COMMITTEE OF EXPERTS ON THE TRANSPORT OF DANGEROUS GOODS AND ON THE GLOBALLY HARMONIZED SYSTEM OF CLASSIFICATION AND LABELLING OF CHEMICALS

Sub-Committee of Experts on the Transport of Dangerous Goods

EXPLOSIVES AND RELATED MATTERS

Report of the Working Group on Explosives

Add Figure 10.5 “Procedure to determine required substance testing for Division 1.6:

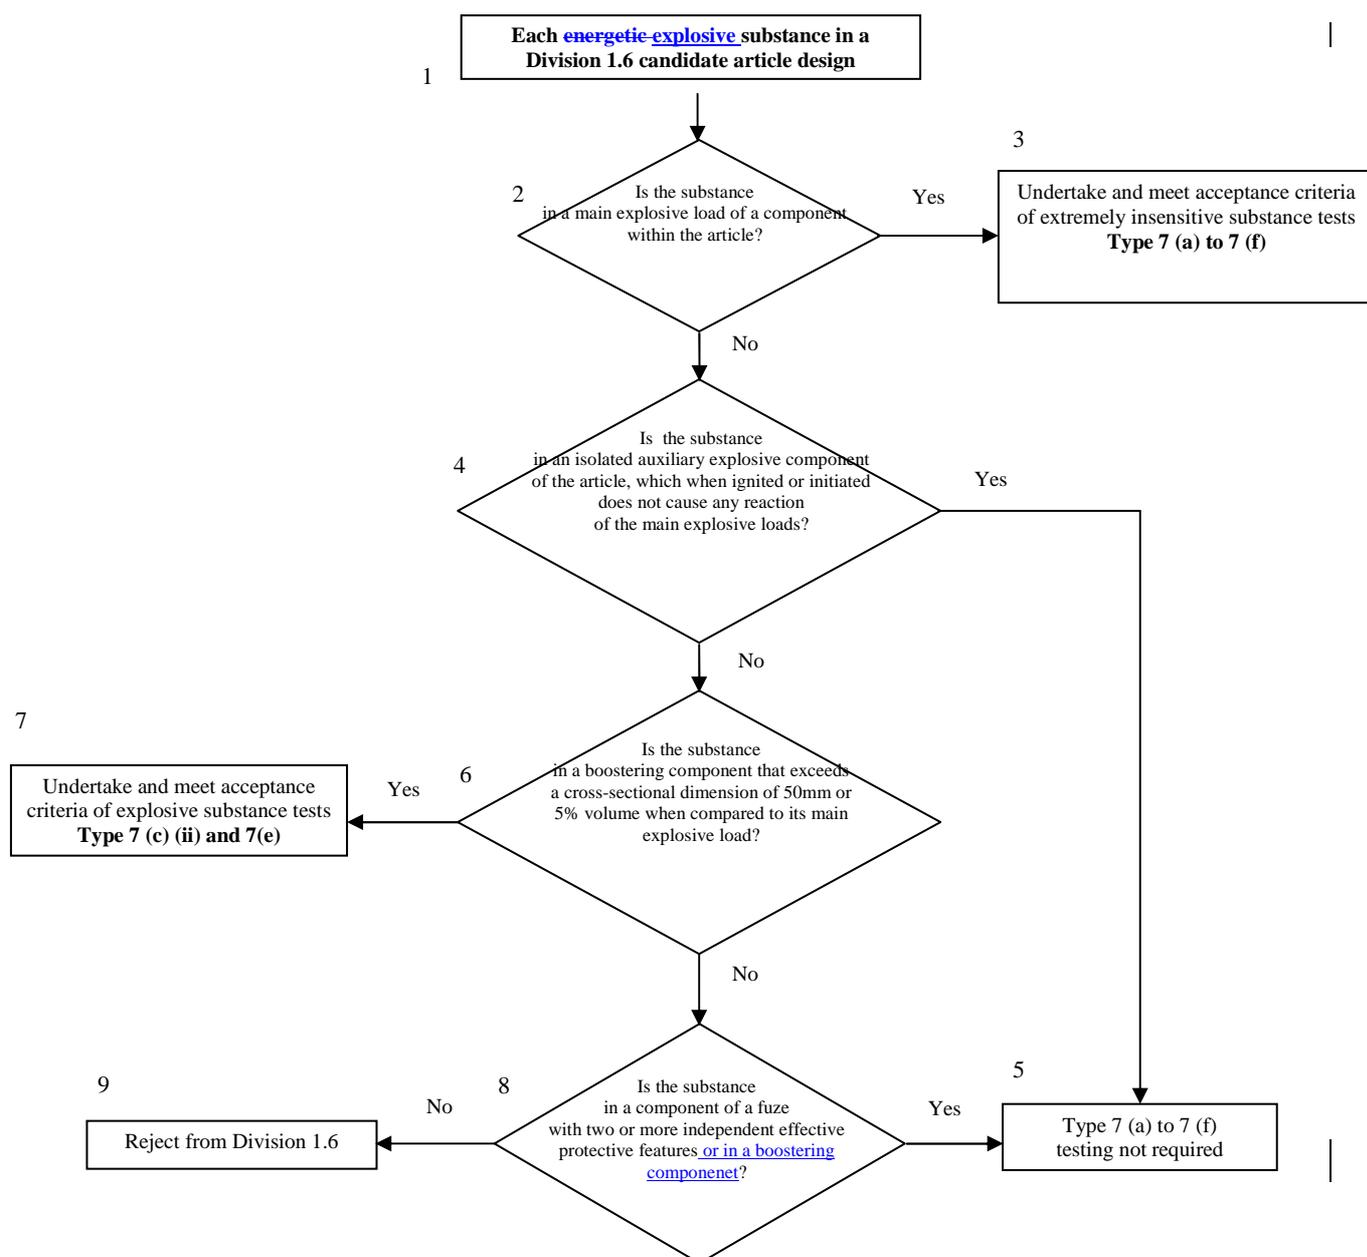
(b) The question “Is the substance in a main explosive load of a component within the article?” (Box 2 of Figure 10.5) is answered by examining the design of the article. Main explosive load substances are those loaded into components within the article that are not fuze, boosting, or isolated auxiliary explosive components. All substances in main explosive loads must “Undertake and meet acceptance criteria of extremely insensitive substance tests, Type 7 (a) to 7 (f)” (Box 3 of Figure 10.5). If a ‘+’ result is obtained for any main explosive load substance to any Type 7 (a) to 7 (f) test, the substance is not an EIS and the answer to the question in Box 24 of Figure 10.3 is “No.” The article is not a candidate for Division 1.6.

(c) Answering the question “Is the substance in an isolated auxiliary explosive component of the article, which when ignited or initiated does not cause any reaction of the main explosive loads?” (Box 4 of Figure 10.5) requires knowledge of the design of the article plus the explosive effects that occur when such components are initiated or ignited, either in their design mode or accidentally. Typically these will be small explosive actuators or pyromechanical devices that produce movement, cutting or opening functions. If the answer is ‘yes’ to this question, Type 7 (a) to 7 (f) testing is not required for substances in isolated auxiliary explosive components and the article remains a candidate for Division 1.6.

(d) The question “Is the substance in a boosting component that exceeds a cross-sectional dimension of 50 millimetres or 5 percent volume when compared to its main explosive load?” (Box 6 of Figure 10.5) is answered by examining the design of the article. All substances in such larger boosting components, including those contained in explosive components of dual-protected fuzes in an article, must “Undertake and meet acceptance criteria of explosive substance tests, Type 7 (c) (ii) and 7 (e)” (box 7 of Figure 10.5). If a ‘+’ result is obtained for any such larger boosting component substance to either Type 7 (c) (ii) and 7 (e) tests, the answer to the question in Box 24 of Figure 10.3 is “No.” The article is not a candidate for Division 1.6.

(e) The question “Is the substance in a component of a fuze with two or more independent effective protective features [or in a boosting component](#)” (Box 8 of Figure 10.5) is answered by an understanding of the design and development of the article. If the answer is ‘no’, the article is not considered to have suitable intrinsic safety characteristics and the answer to the question in Box 24 of Figure 10.3 is ‘No’ the article is not a candidate for Division 1.6.”.

“10.4.3.7 Tests of types 7 (g), 7 (h), 7 (j), 7 (k) and 7(l) should be performed to determine if an article with EIS main explosive load(s) and appropriately insensitive boosting components may be assigned to Division 1.6. These tests are applied to articles in the condition and form in which they are offered for transport, except that non-explosive components may be omitted or simulated if the competent authority is satisfied that this does not invalidate the results of the tests. The procedure detailing testing requirements is given in Figure 10.5 and some points of explanation are given below.

Figure 17.14.1 Standard fragment for 1.6 article fragment impact test

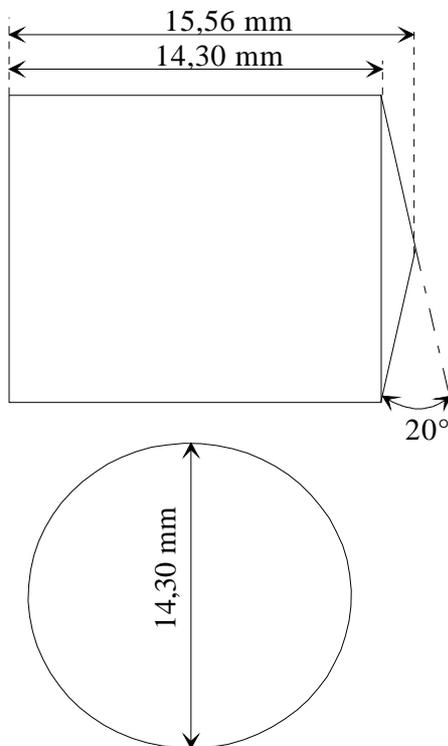
To reduce variability due to yaw, a gun system is recommended for firing a standard 18.6 gram steel fragment in the shape of a right-circular cylinder with a conical nose, as detailed in Figure 17.14.1, at a candidate Division 1.6 article. The distance between the firing device and the test item should ensure that the fragment is

Figure 17.14.2 Typical setup for 1.6 article fragment impact test”

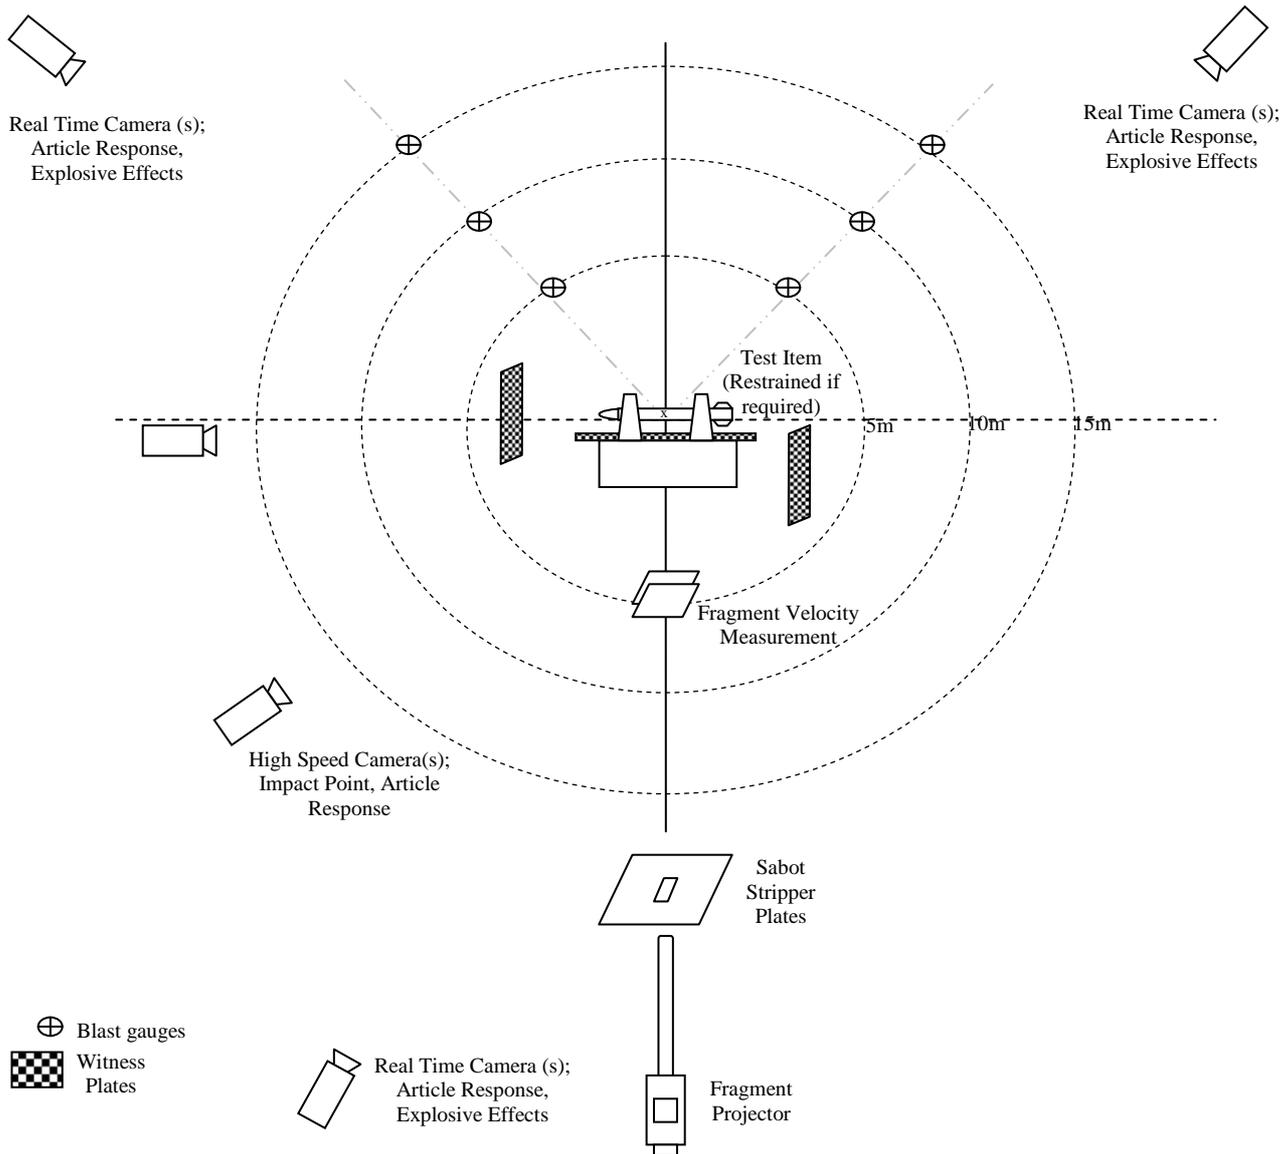
This test is used to determine the response of an article in its transport configuration to a localised shock input representative of a fragment strike typical of that produced from a nearby detonating article.
